**ADDENDUM NO. 2**

**KENDALLVILLE PUBLIC LIBRARY RENOVATION  
MAIN AND LIMBERLOST BRANCHES  
MSKTD Project No.: 8045  
May 9, 2025**

**First Floor Reflected Ceiling Plan Unit "A"**  
1/8" = 1'-0"

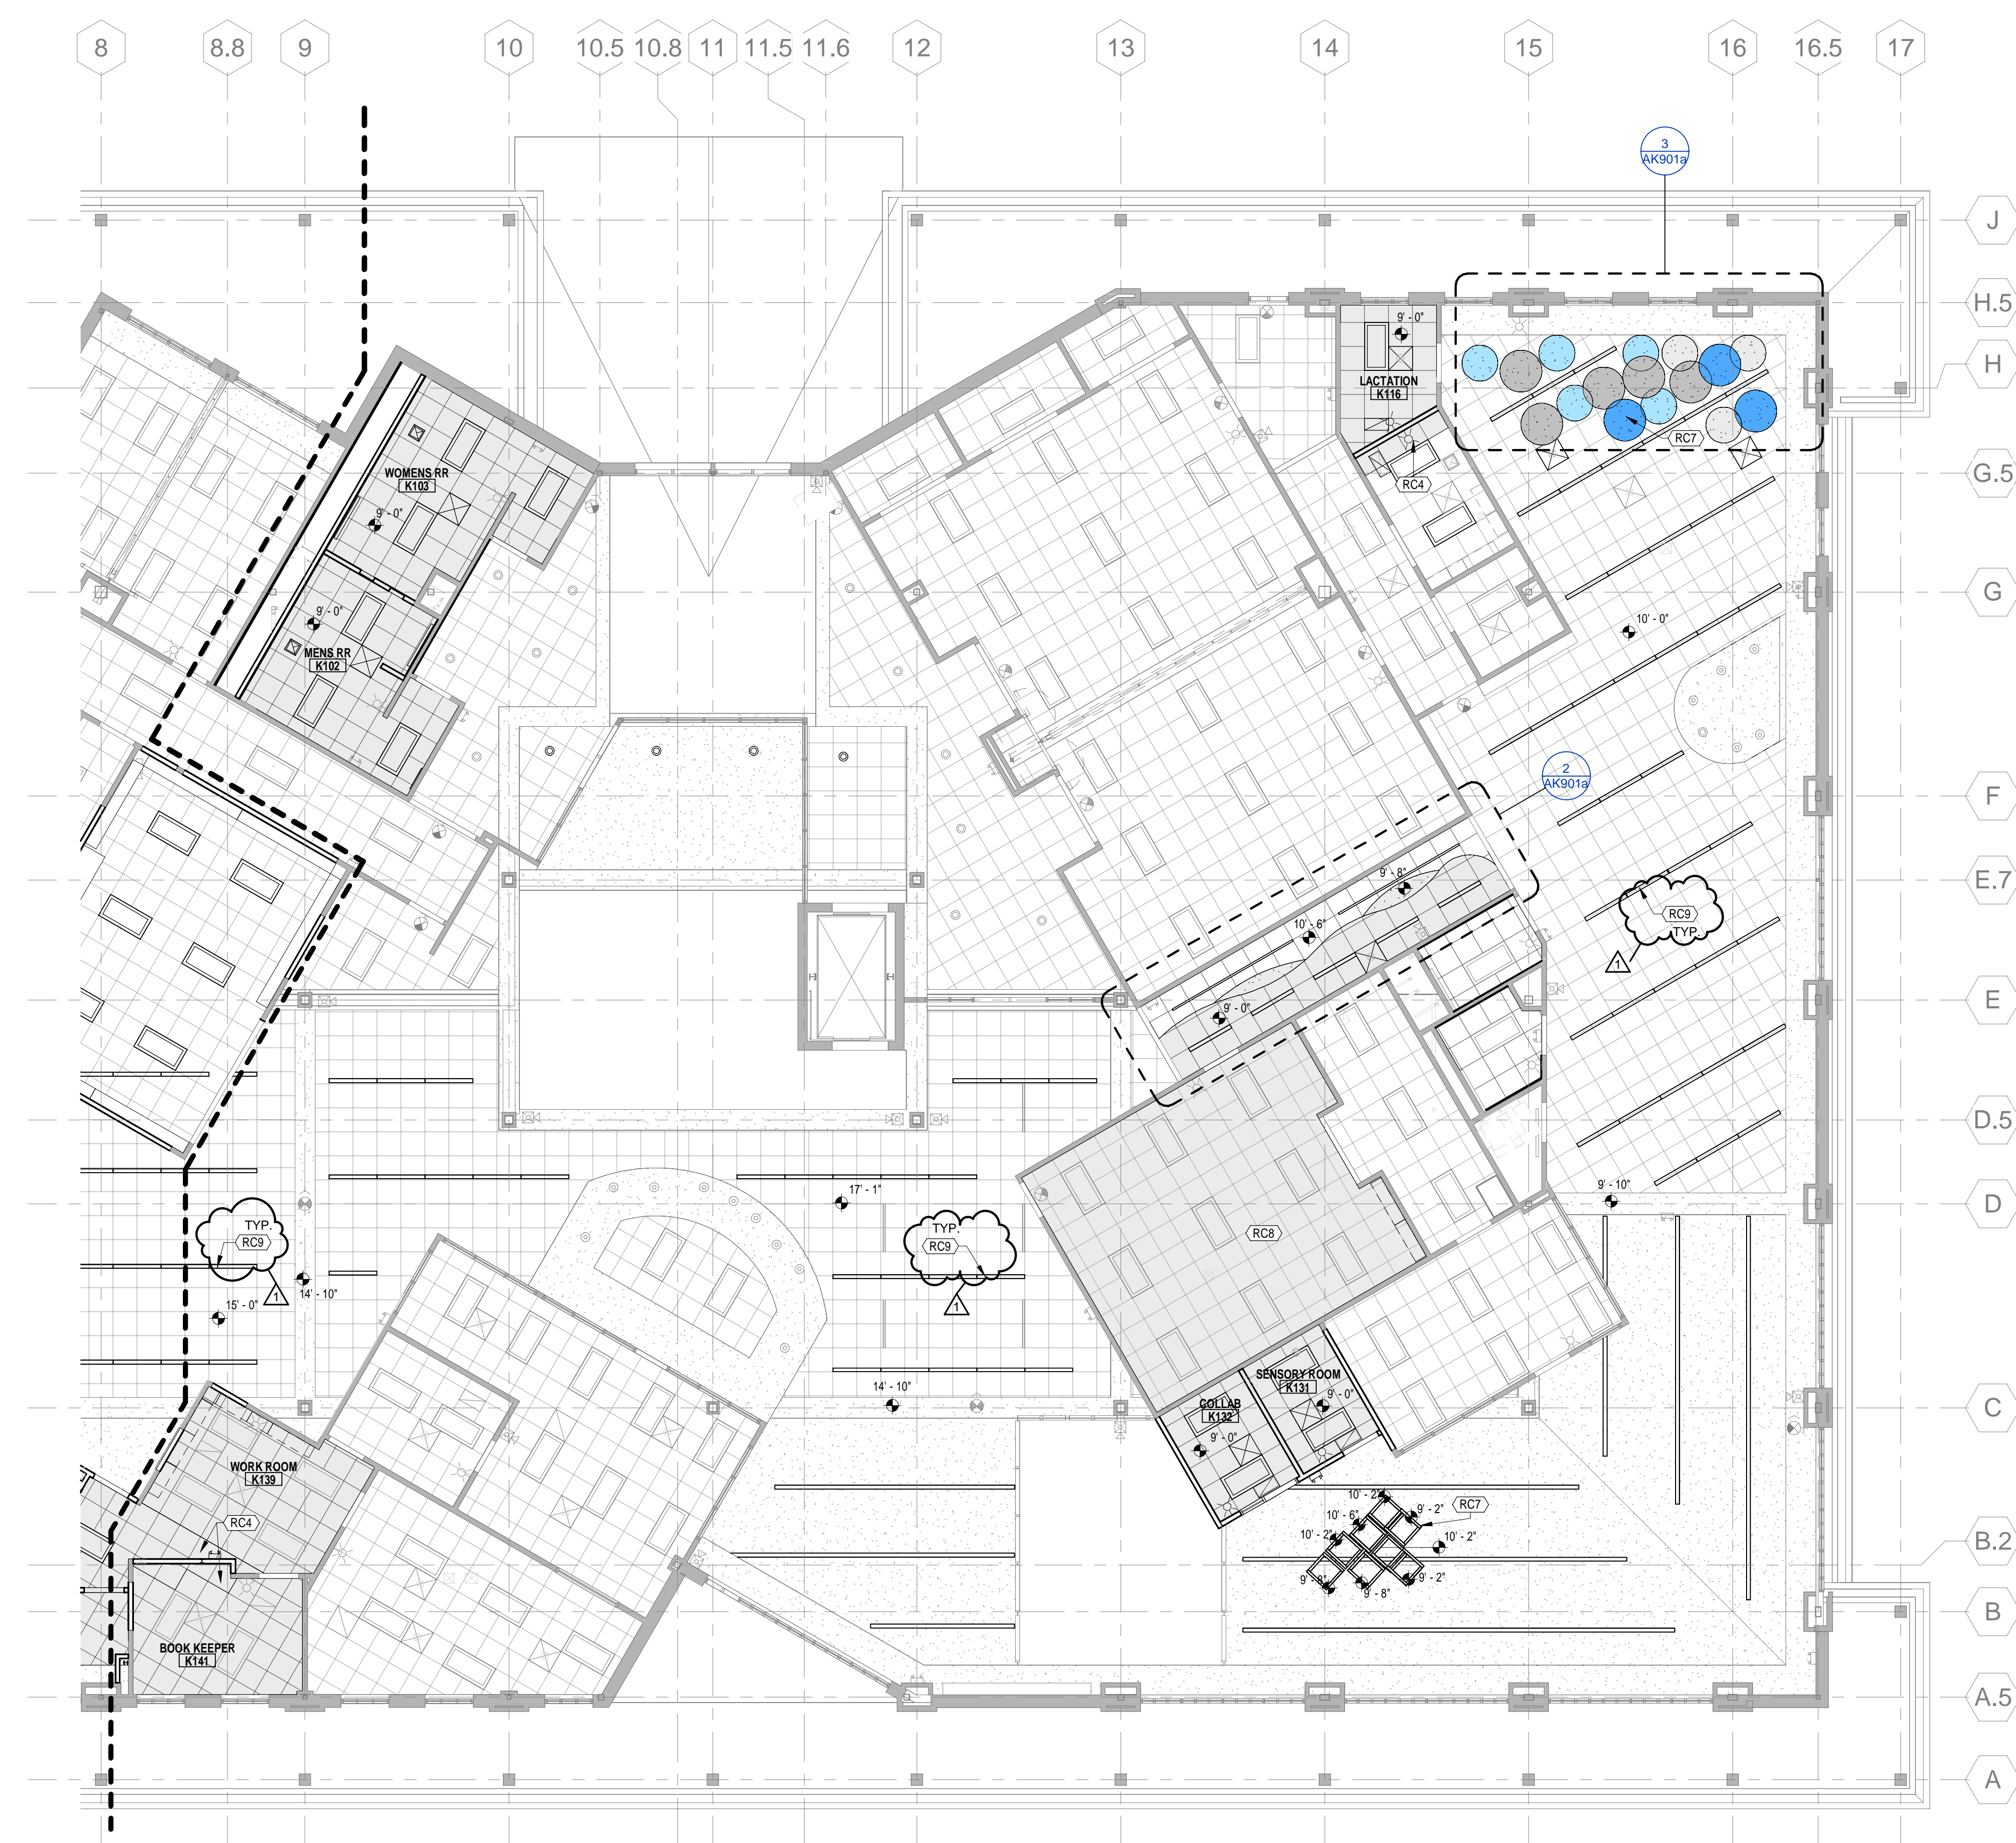
2.3	Drawings Sheet AK901a	Refer to attached, revised sheet AK901a for the following clarifications/revisions: 1. KPL - First Floor Reflected Ceiling Plan Unit A. Note RC9 has been added to the drawing: "NEW LINEAR LIGHT FIXTURES TO BE INSTALLED IN EXISTING SUSPENDED ACOUSTIC CEILING SYSTEM. G.C. TO MODIFY THE EXISTING GRID AND CUT TILES AS REQUIRED TO ACCOMMODATE NEW LIGHT FIXTURES. SEE ELECTRICAL LIGHTING PLANS FOR MORE INFORMATION ON FIXTURE TYPE(S). NEW LIGHT FIXTURES ARE TO RUN PARALLEL WITH EXISTING MAIN GRID TEES, TYPICAL."

**KPL - First Floor Reflected Ceiling Plan Unit "B"**  
1/8" = 1'-0"

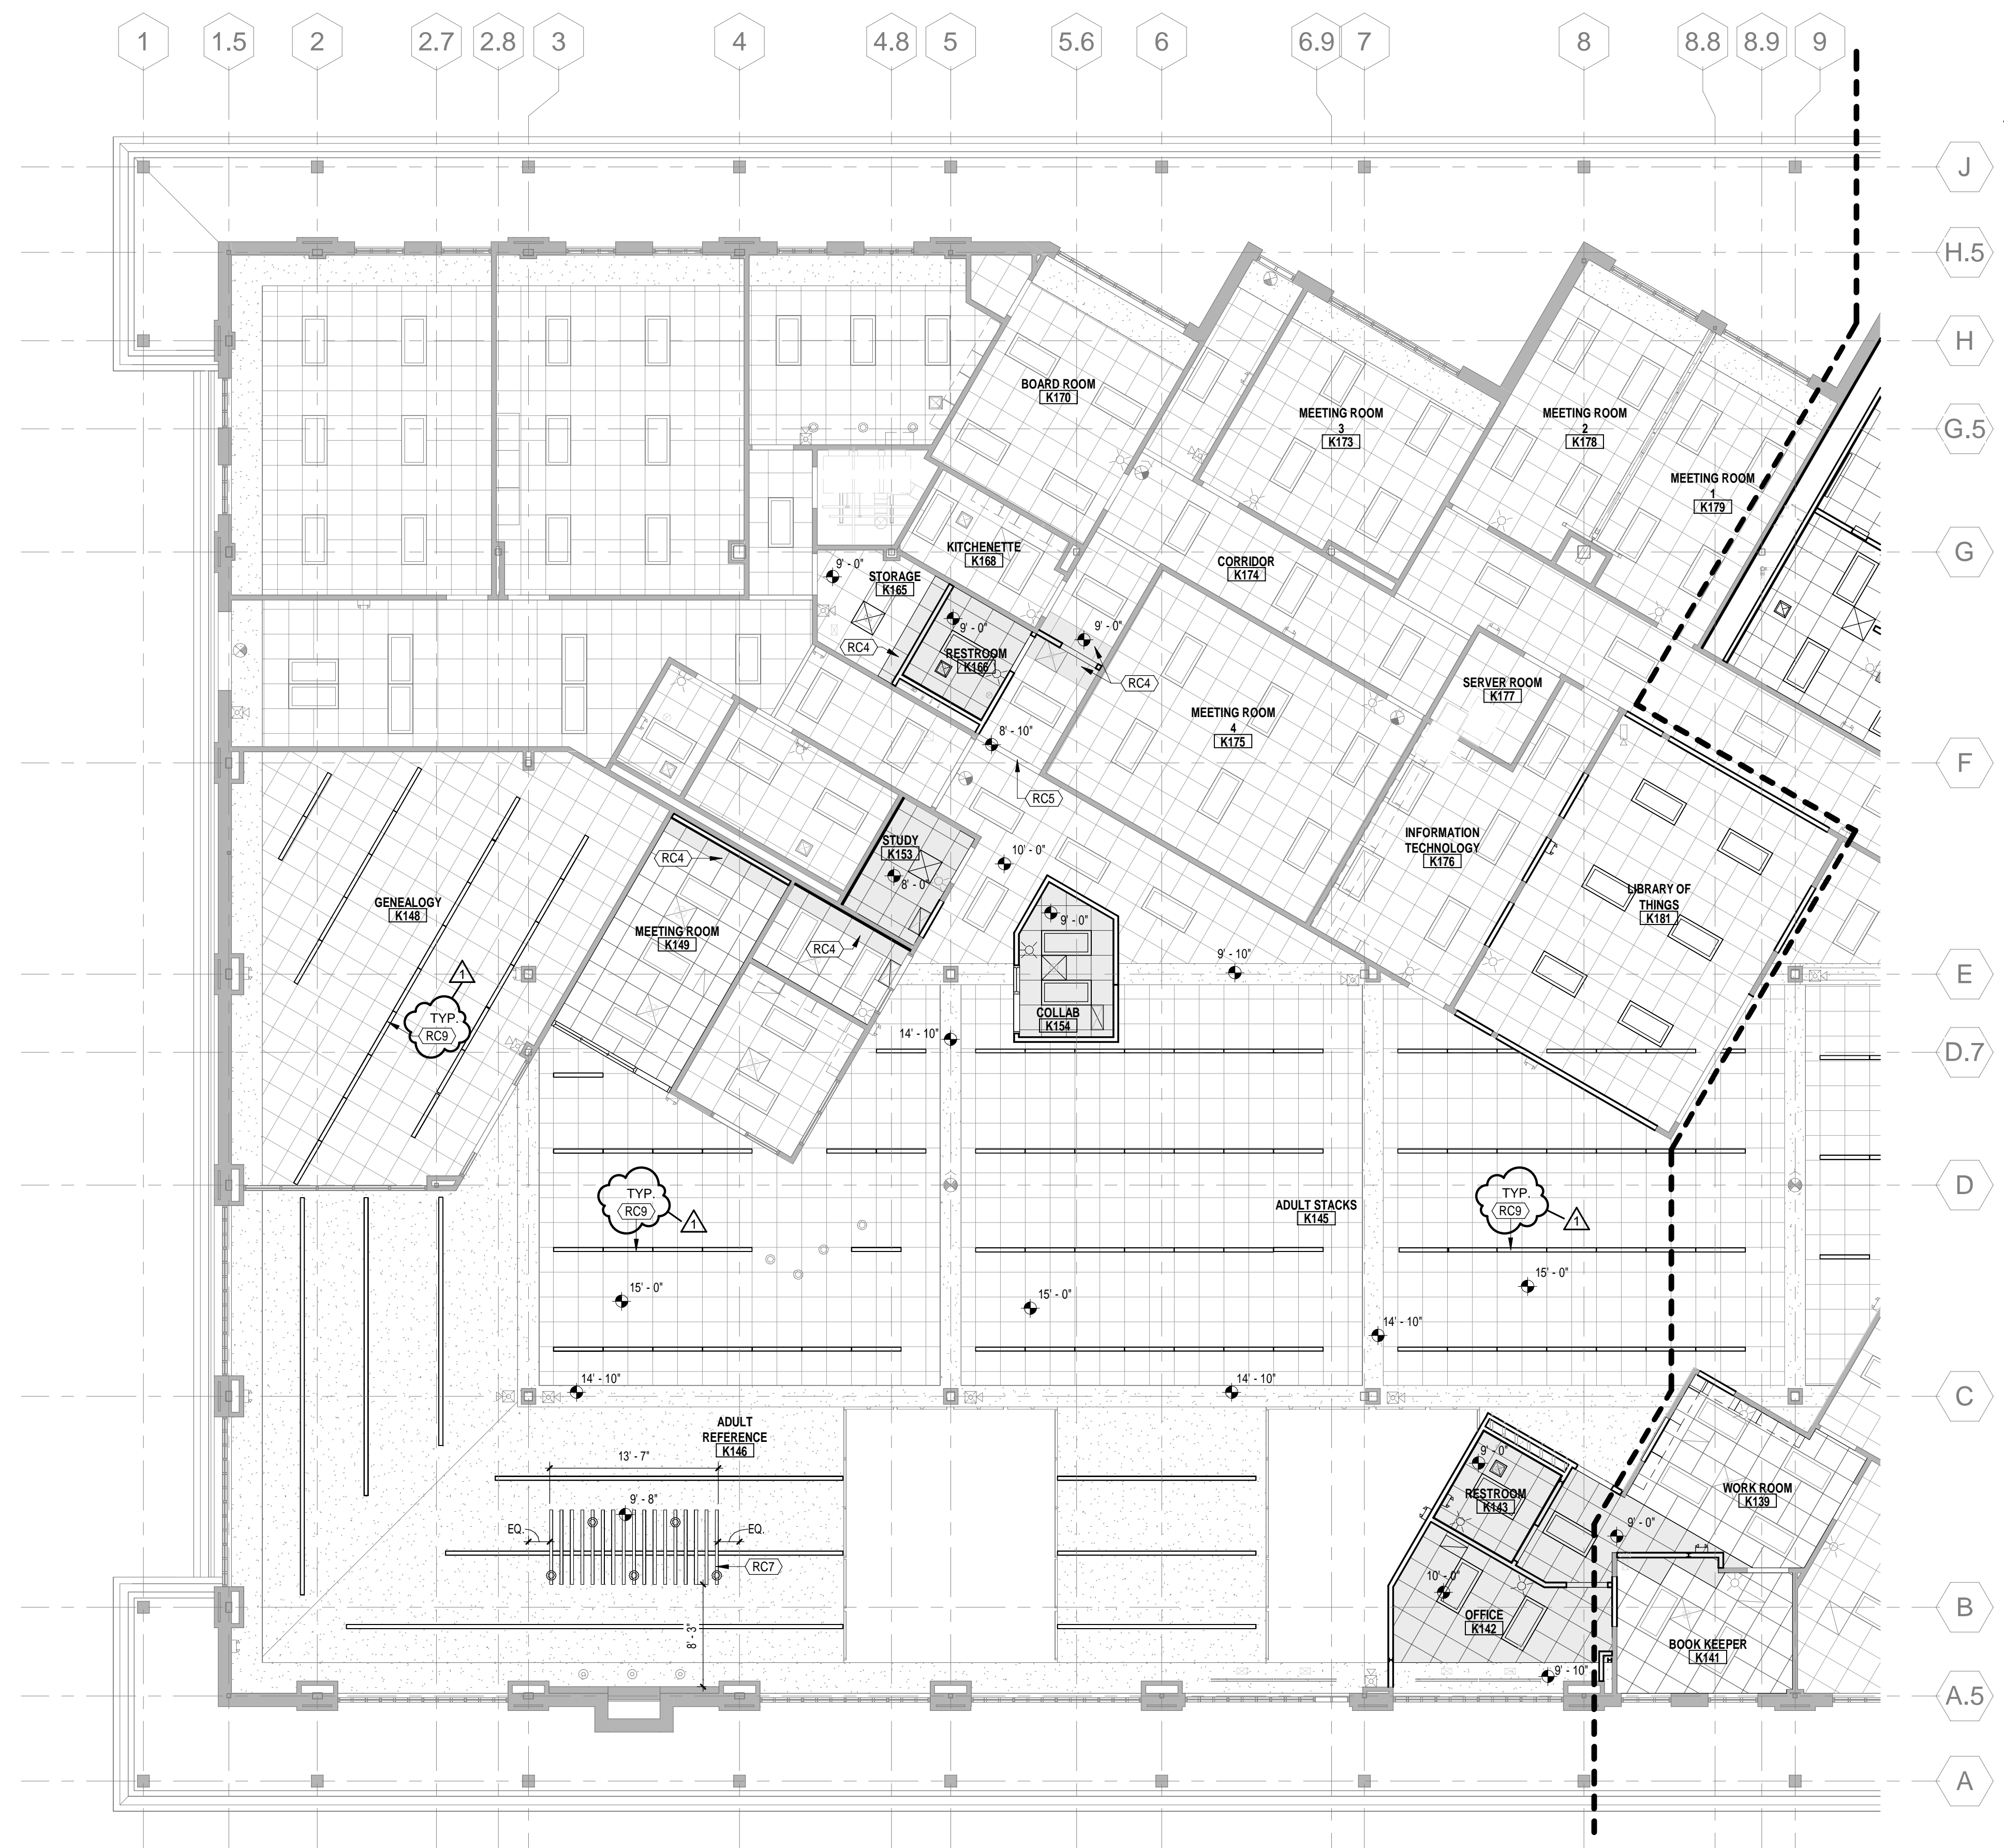
2.4	Drawings Sheet AK901b	Refer to attached, revised sheet AK901b for the following clarifications/revisions: 1. KPL - First Floor Reflected Ceiling Plan Unit B. Note RC9 has been added to the drawing: "NEW LINEAR LIGHT FIXTURES TO BE INSTALLED IN EXISTING SUSPENDED ACOUSTIC CEILING SYSTEM. G.C. TO MODIFY THE EXISTING GRID AND CUT TILES AS REQUIRED TO ACCOMMODATE NEW LIGHT FIXTURES. SEE ELECTRICAL LIGHTING PLANS FOR MORE INFORMATION ON FIXTURE TYPE(S). NEW LIGHT FIXTURES ARE TO RUN PARALLEL WITH EXISTING MAIN GRID TEES, TYPICAL."
